Project Number 1454

Subject: Final Submission of Second Work Plan Addendum
Sites 1 through 5, Site Characterization and Evaluation
Naval Aviation Depot, MCAS Cherry Point, North Carolina

1.0 INTRODUCTION

FIGURE 3-5

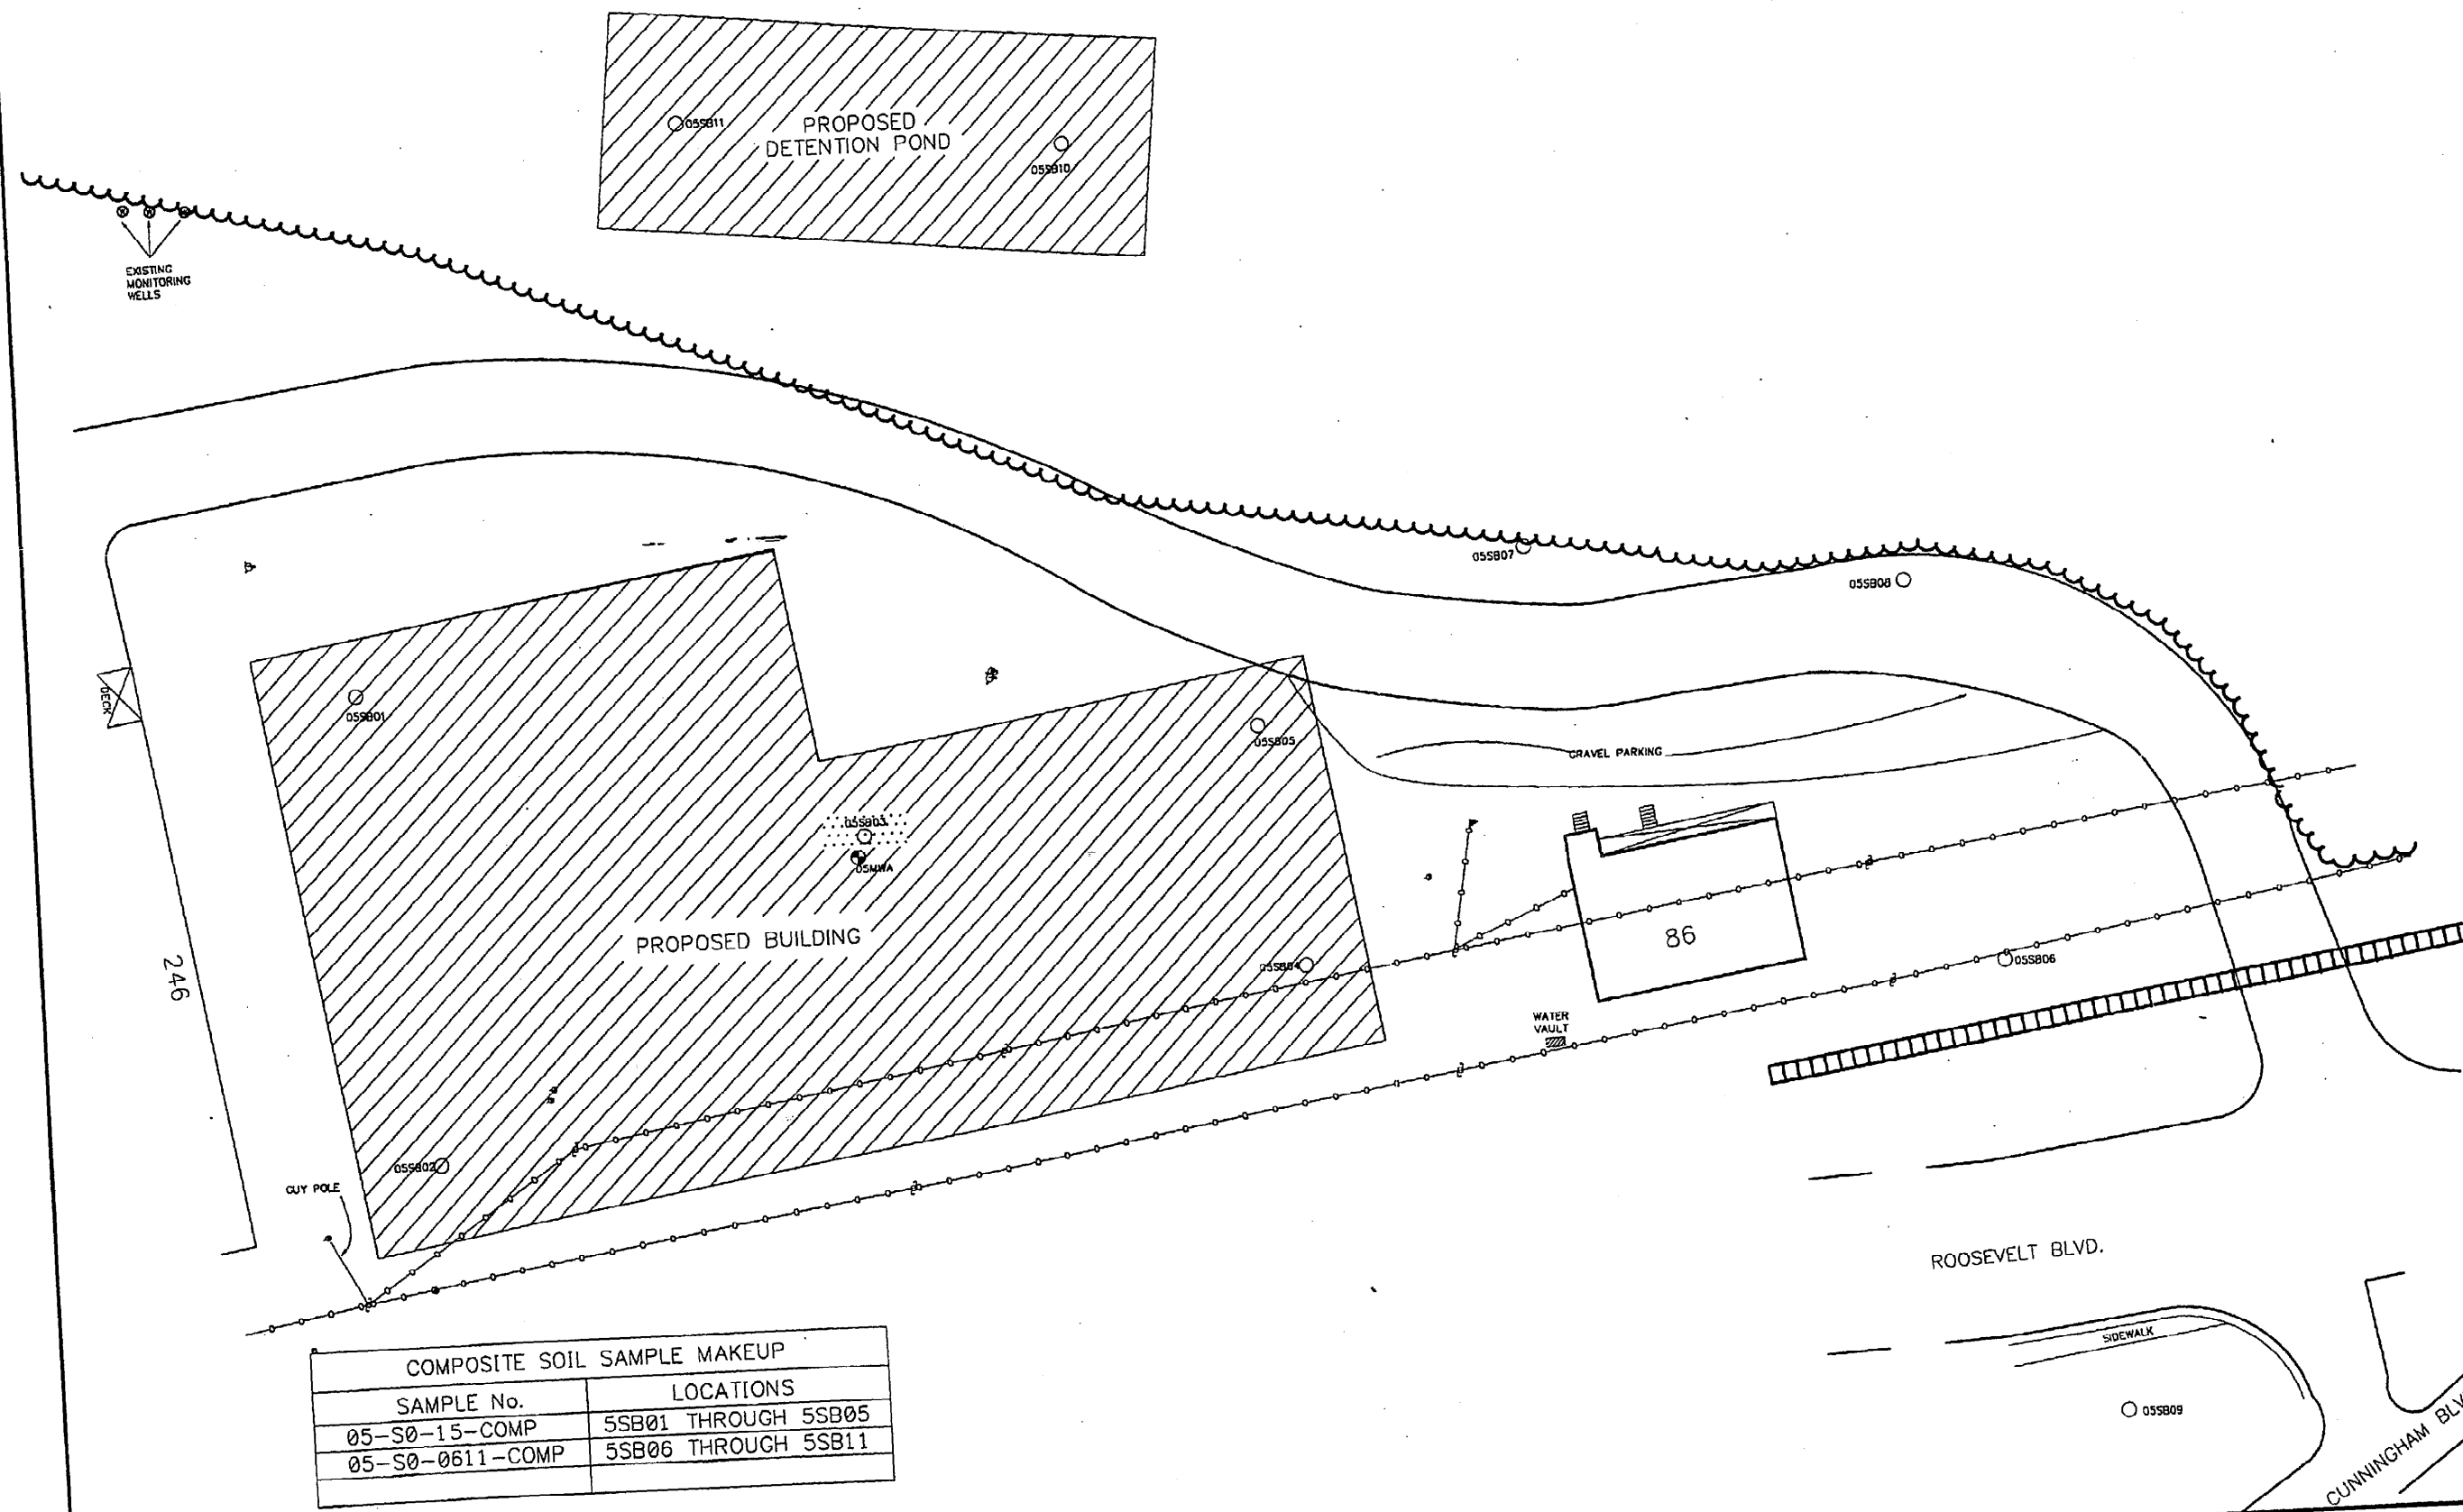
"A discrete surface soil (0-1 foot depth) sample will be taken at sample location SB03 and will be analyzed for TCL volatiles, TCL semi-volatiles, TCL pesticide/PCBs, TAL metals/cyanide, low/medium/high TPHs, and oil and grease.

Figure 3-5 shows the locations of the soil samples taken during the initial investigation, the maximum depth sampled, areas of proposed excavation, and the proposed surface soil sample location.
